EVALUATION OF EMERGENCY RESPONSE FACILITIES FOR
FORT CALHOUN STATION - UNIT 1

October 1981

Pacific Northwest Laboratory
Richland, Washington 99352

1. SUMMARY AND RECOMMENDATIONS

FIGURE 2.1

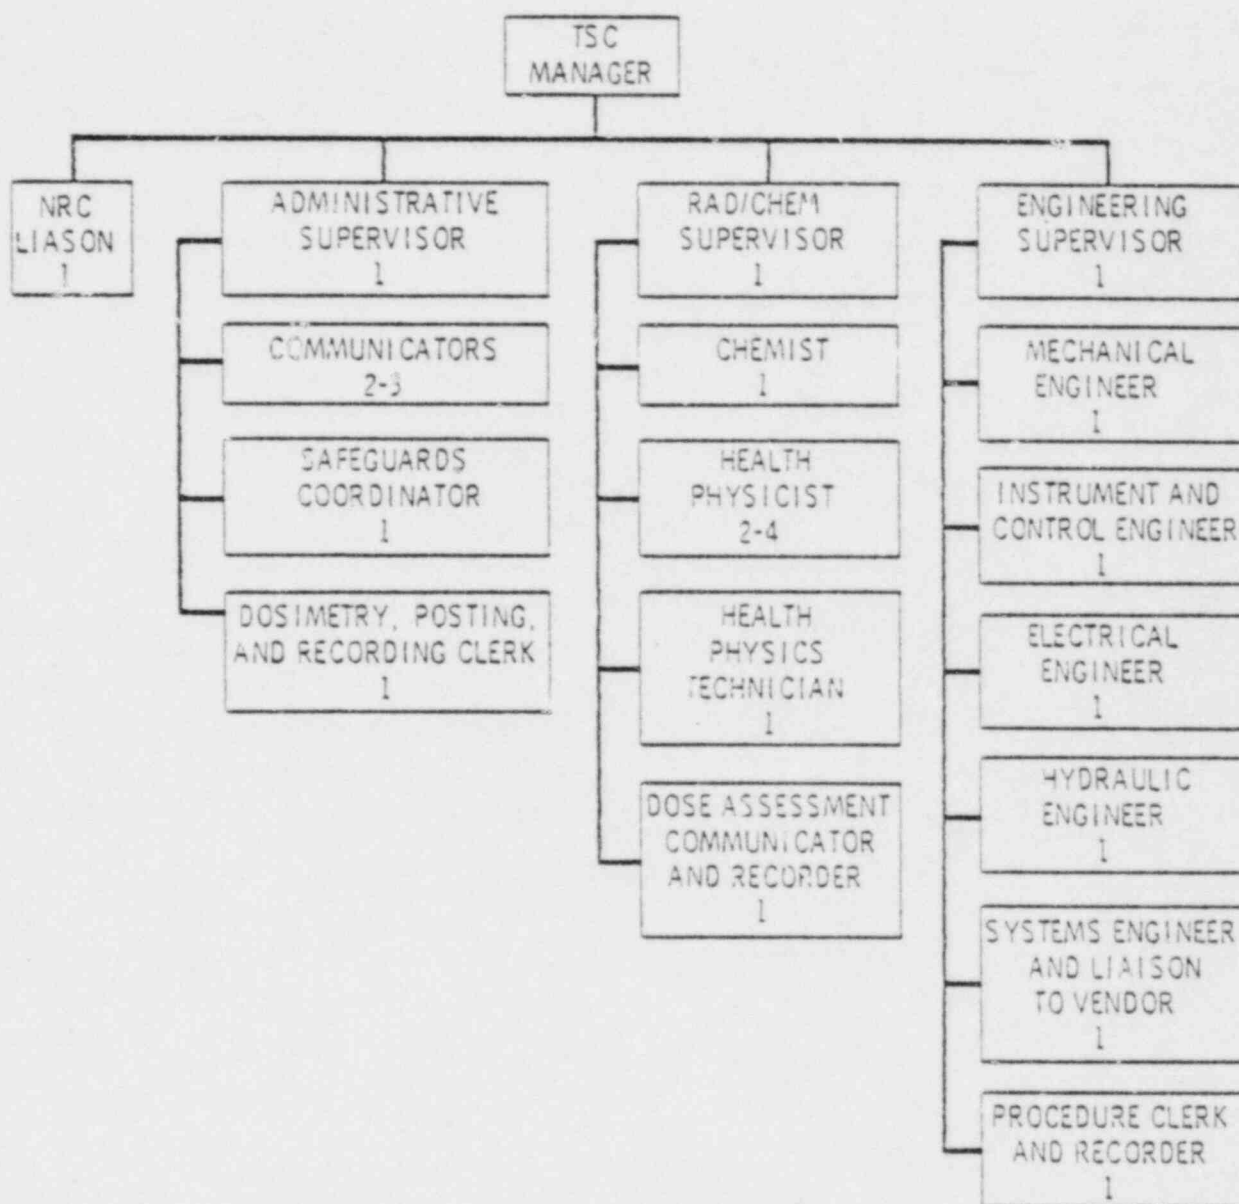
Describe the organization of the work stations. Are they organized according to Figure 2.1?

- b. Consist of sufficient technical personnel needed to support the control room including individuals who can handle situations involving operations, maintenance, administration, security, Rad/chem, and communications (Figure 2.1 is an example only).

FIGURE 3.1

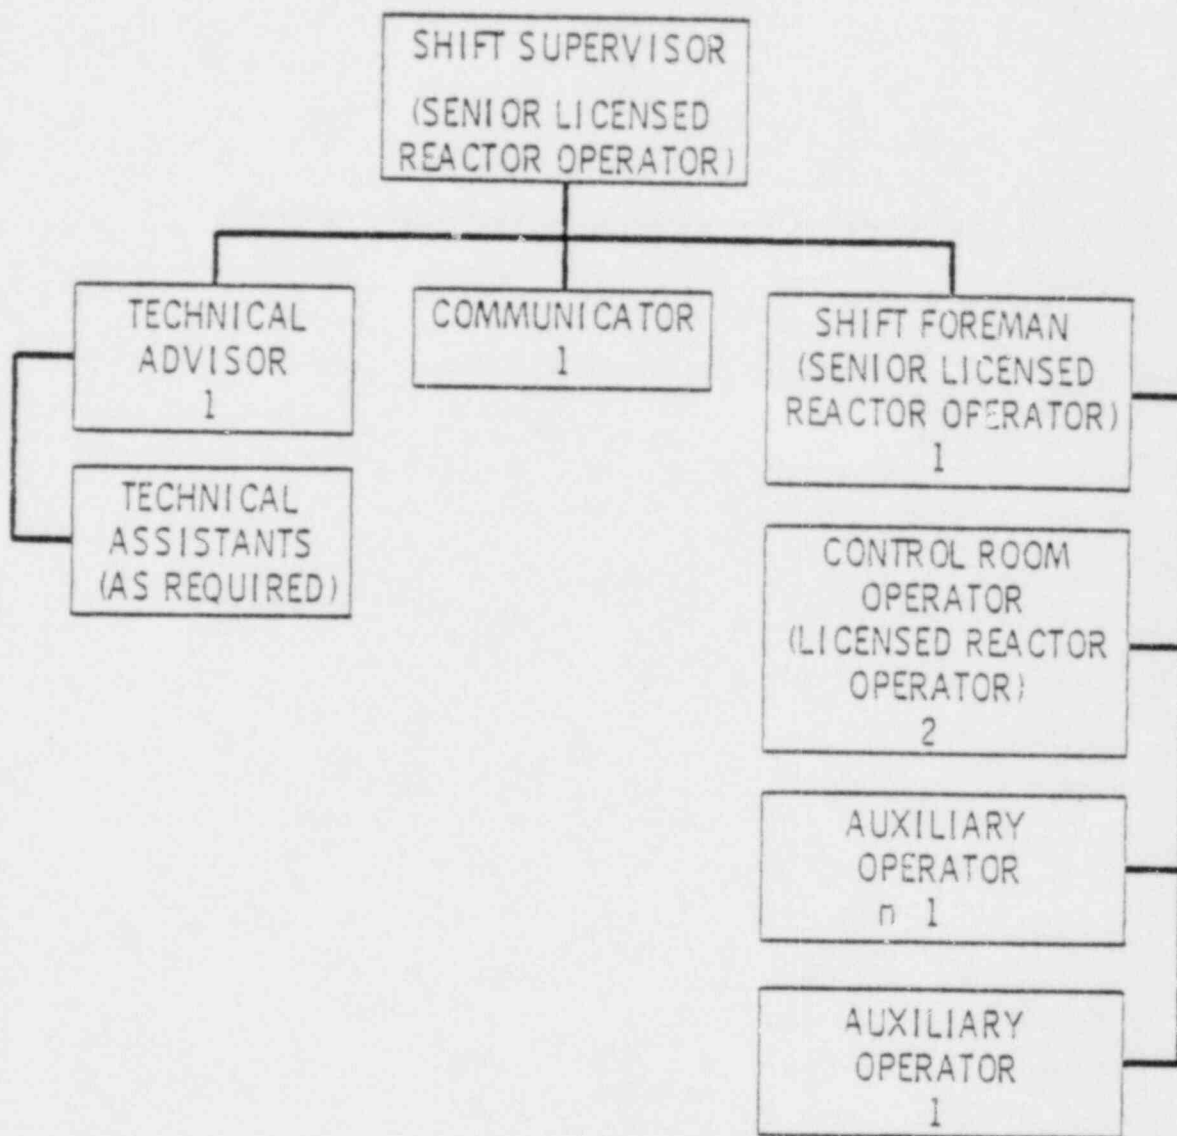
1. The personnel organization in the control room is shown in Figure 3-1.
2. The succession of authority if the senior person is incapacitated or unavailable must be addressed.
3. The functional organization in the control room during an abnormal event is shown in Figure 3-2.

FIGURE 5.2

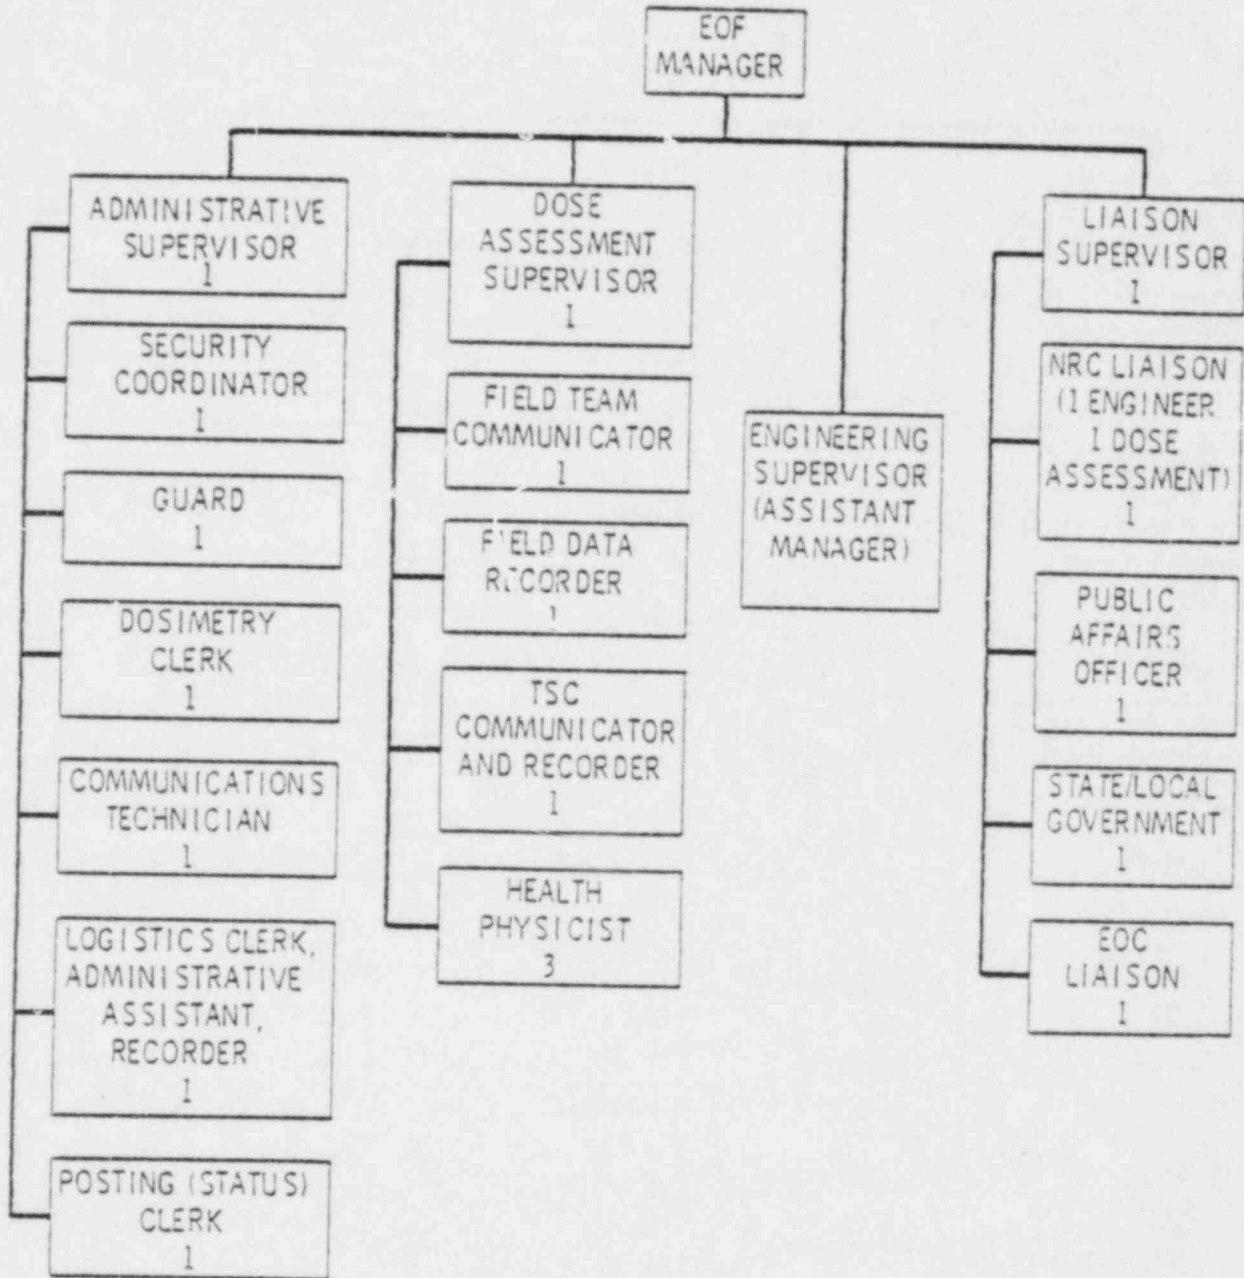
| Describe the organizations of the work stations. Are they organized according to Figure 5.2? | Insufficient information. |
